OFFICE OF THE COUNCIL
MEETING PACKET FOR THE
COMMITTEE OF THE WHOLE
NOVEMBER 19, 2025
6:00 P.M.

1. The subject matter of Petition 2025-07-02-15, submitted by Mannik & Smith Group, on behalf of Clean Express Car Wash, requesting waiver use approval to operate an Auto-Wash Establishment, at 38888 Six Mile Road, located at the N.E. corner of Fox Drive and Six Mile Road in the S.W. ¼ of Section 7. (CR 340-25).

Plan Review for: **Clean Express Car Wash**
38888 6-Mile Rd, Livonia MI
Petition 2025-07-02-15

SCALE: 3/16" = 1'-0" (UNO.)
SHEET # / DESCRIPTION
FLOOR PLAN
A1-1
DATE: 07.10.2025
PLANNING COMMISSION
SBA STUDIOS PROJECT # 2025-371

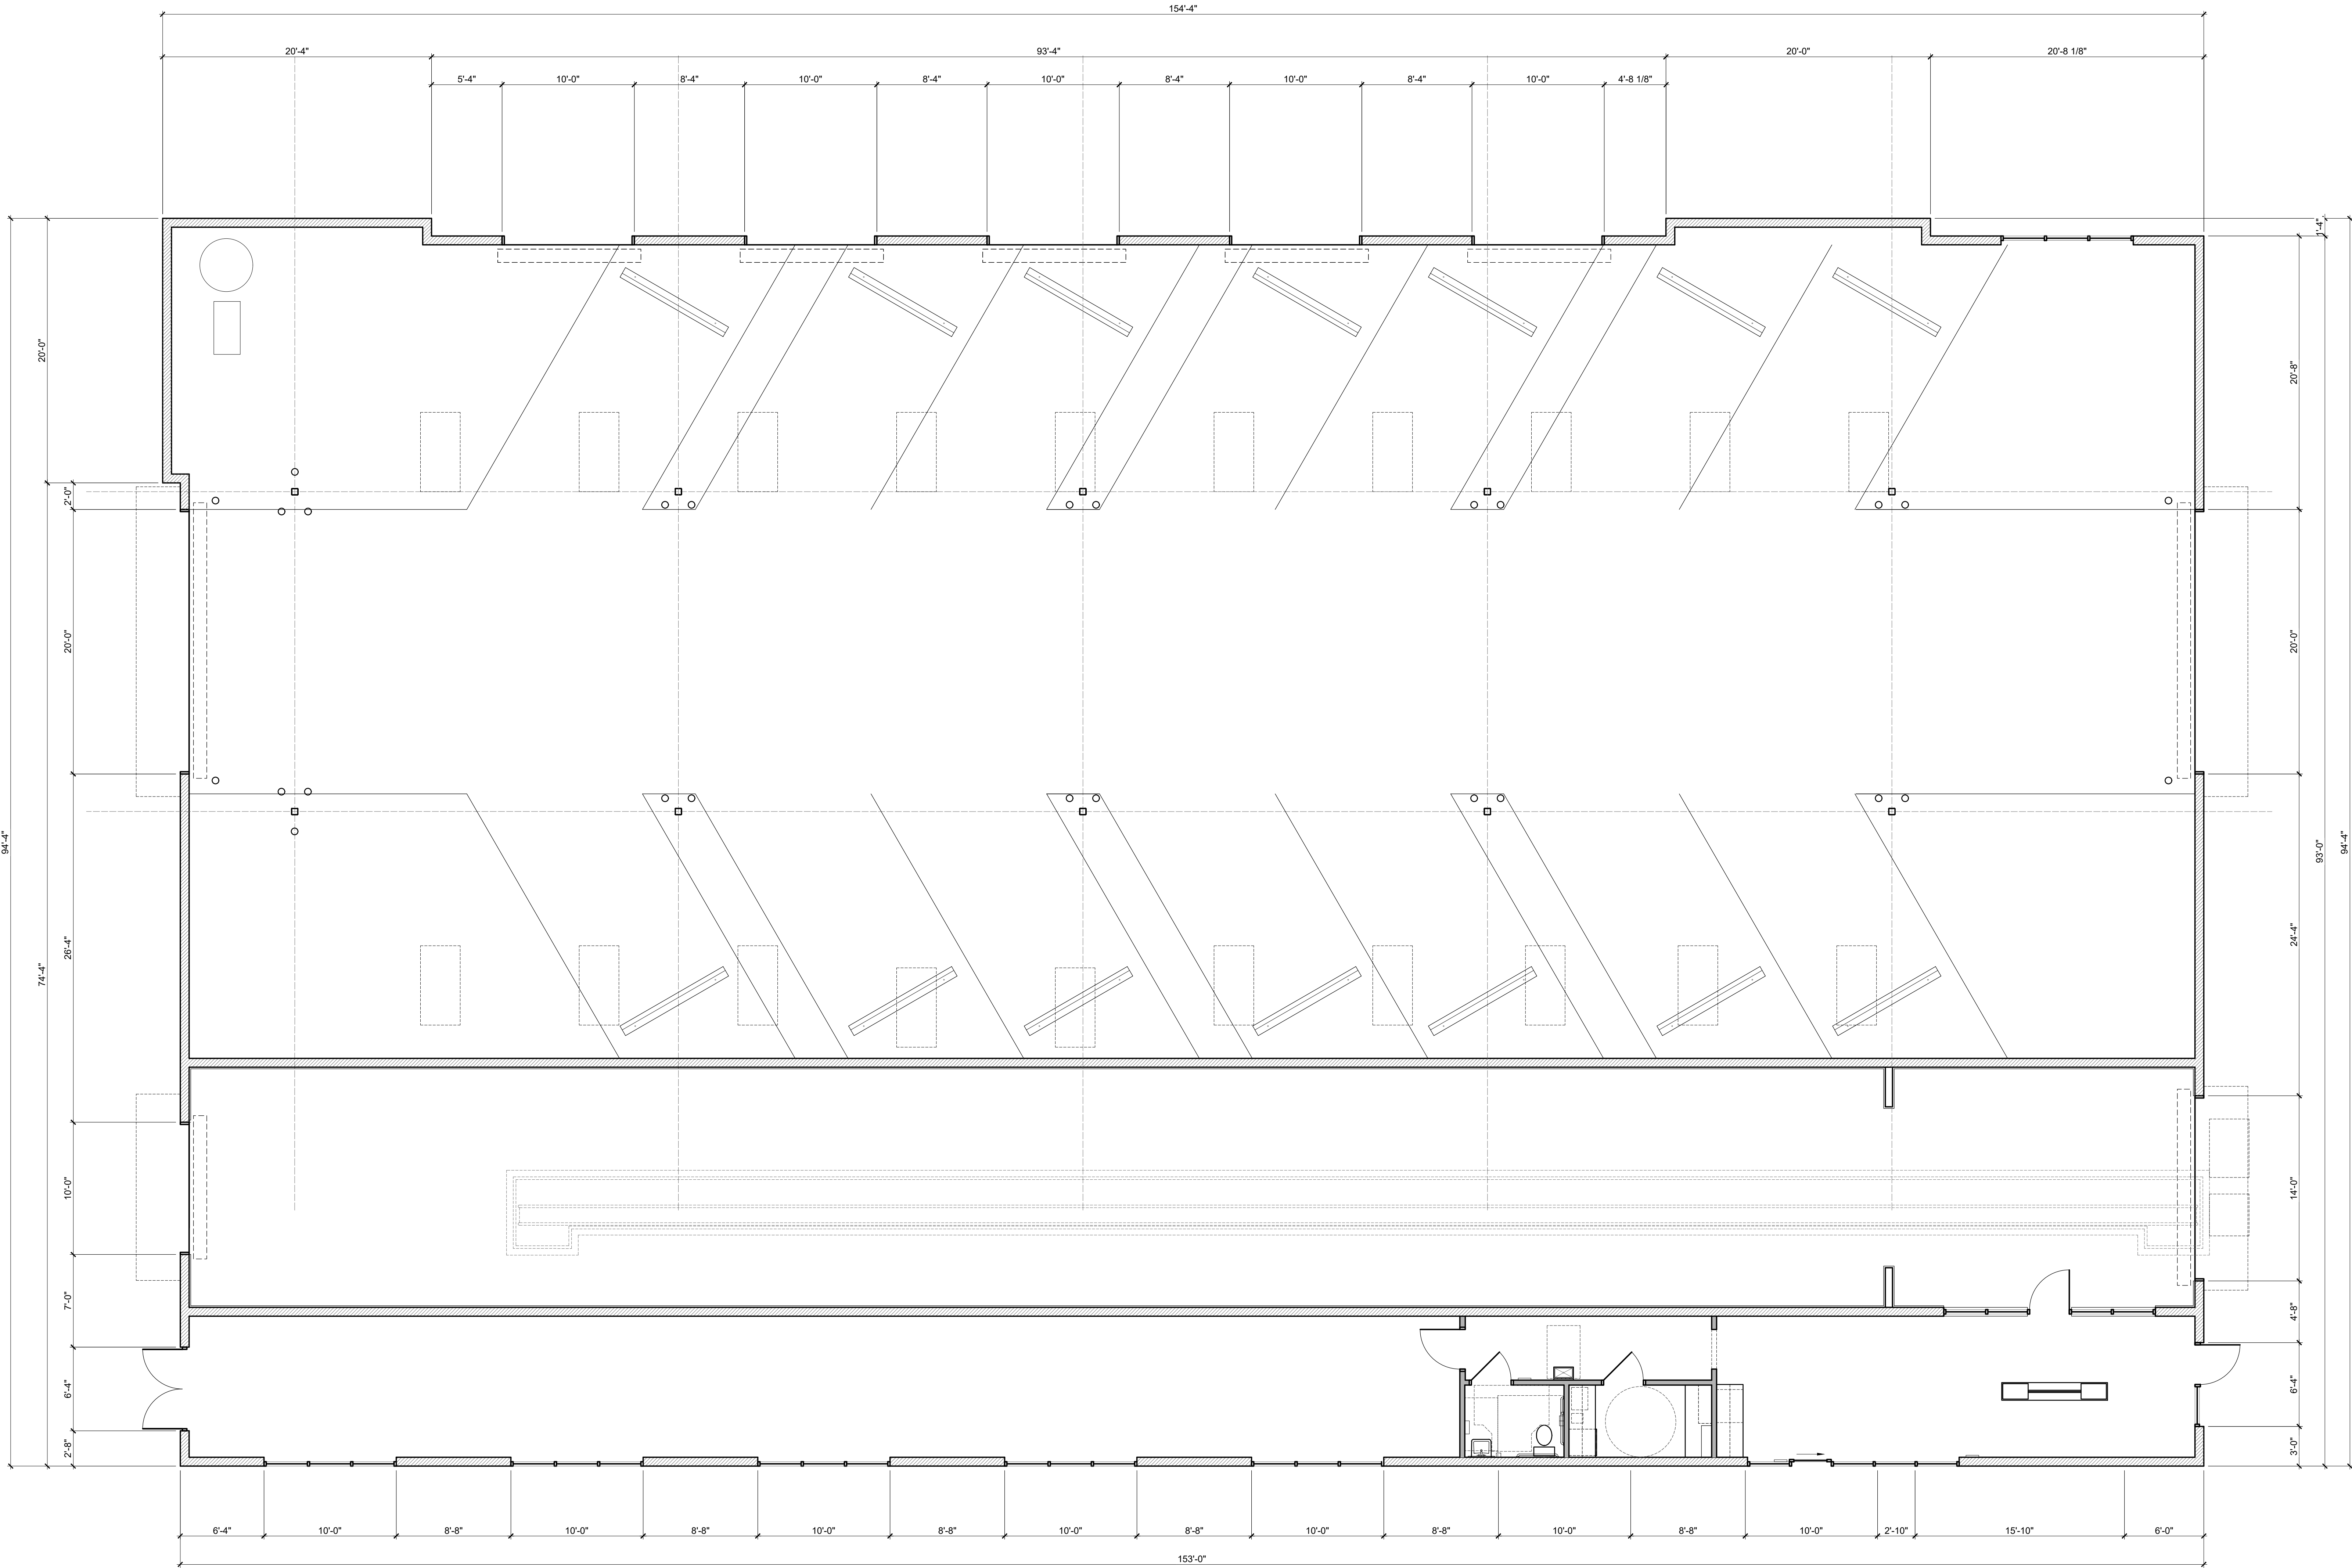
According to the Floor Plan, Sheet A1-1, dated July 10, 2025, there will be three (3) separate portions of the building; the car wash bay, the indoor vacuums, and the office/bathrooms/equipment rooms. The petitioner should label the different portions clearly on the site plan. Elevations show the building built with Quik-Brick, both light finish ($\frac{3}{4}$ top) and dark finish (bottom $\frac{1}{4}$). There will be Nichiha Fiber Cement AWP181 Horizontal siding for the wall with the Car Wash logo.

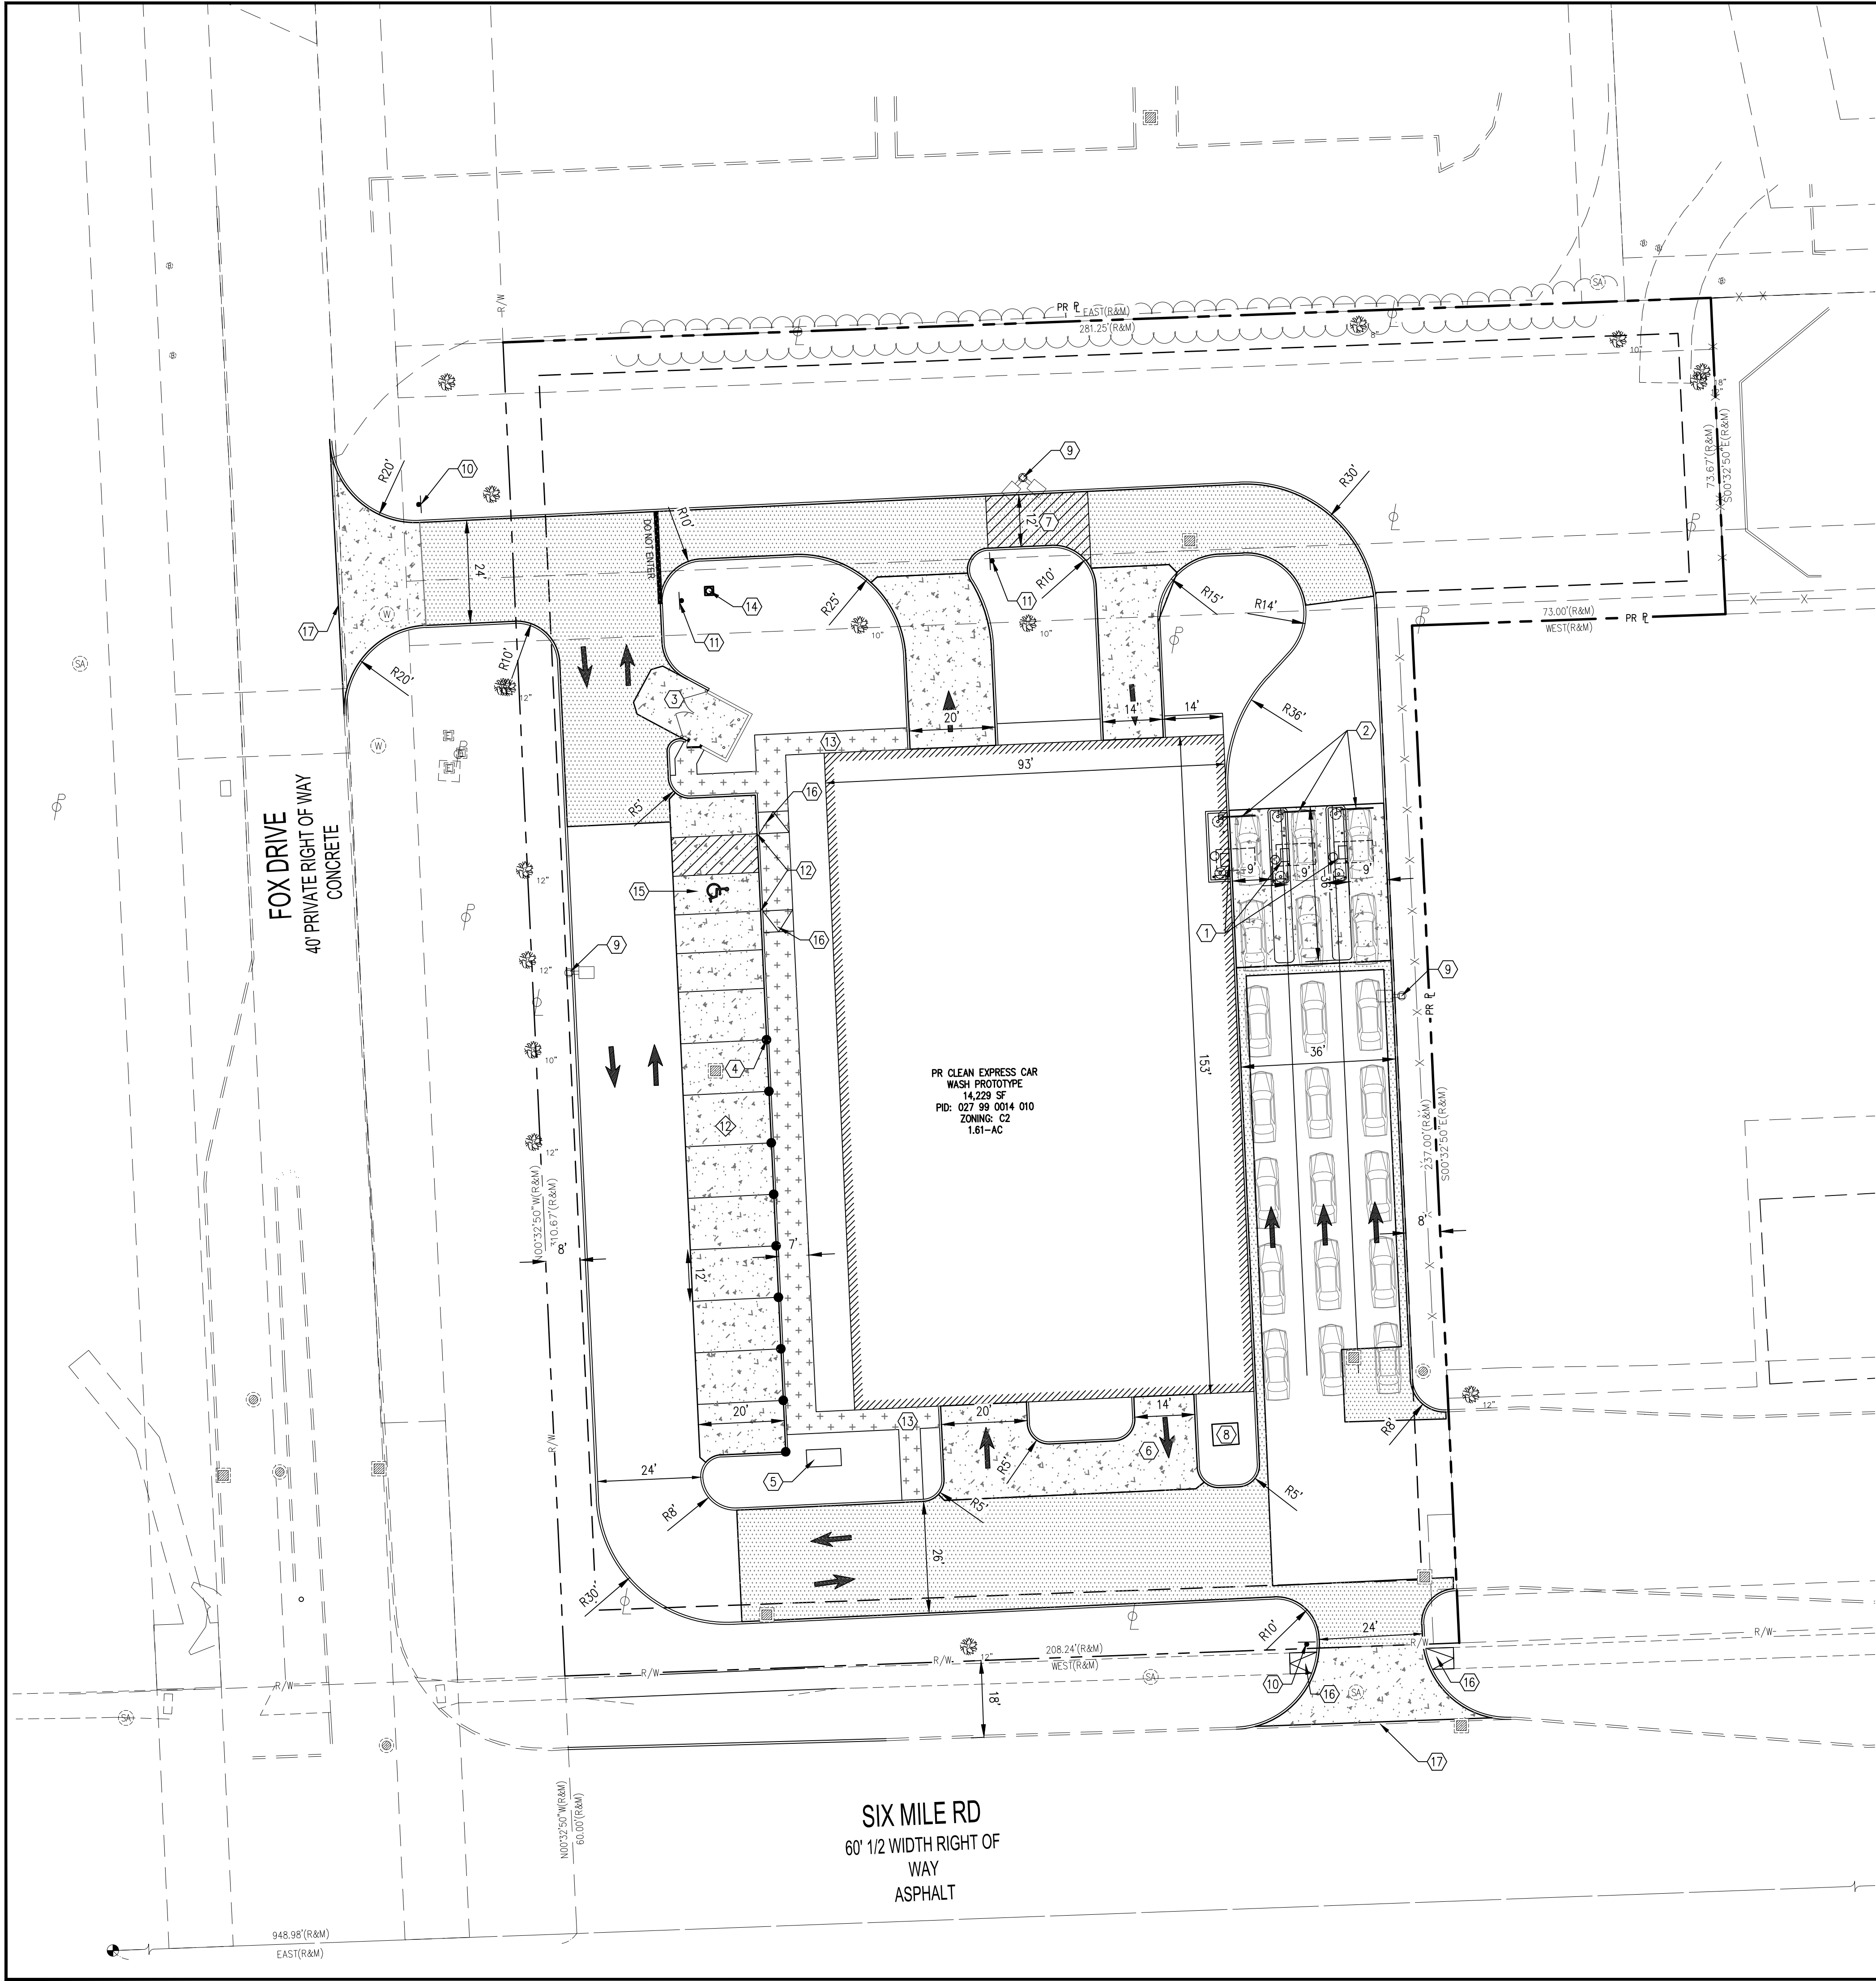
According to Site Plan, Sheet C200 submitted July 31, 2025, the site will be reconfigured to have the ingress from Six Mile Road moved from the southwest corner to the southeast corner of the property. The vacant restaurant building will be demolished and replaced with a brand-new 23-foot, 14,229-square-foot auto wash building. The building's dimensions are 93.0 feet x 153.0 feet. The proposed building will meet both front (15') and rear (8') minimum setback requirements. Section 6.07 requires that a building be situated no closer than 35 feet on one (1) side of the property and eight (8) feet on the other. The building will be approximately sixty feet (60') from the west property line, and approximately forty-

1. That the Site Plan marked Sheet C200 dated July 9, 2025, as revised, prepared by Mannick Smith Group is hereby approved and shall be adhered to, except as may be modified below.
2. That the Demolition Plan marked Sheet C101 dated July 9, 2025 as revised, prepared by Mannick Smith Group is hereby approved and shall be adhered to.
3. That the Landscape Plan marked Sheets L100 and L101 dated July 9, 2025, as revised,
